FREEBOARD REPORT on the "Antinea"

Sheer aft.

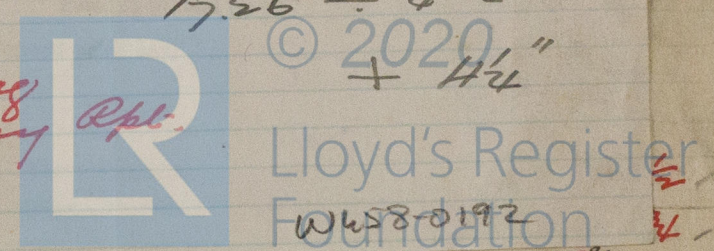
40.0
~~18.25~~ ÷ 4 = ~~4.56~~
 17.26

Correction

should be reported on the breadth of vessel at the gunwale.

40
 17.26 ÷ 4 =
 + 4 1/4"

N. A. Winter Freeboard 4.040
 Correction necessary because clearside amidships, measured) 4.706 9 1/2
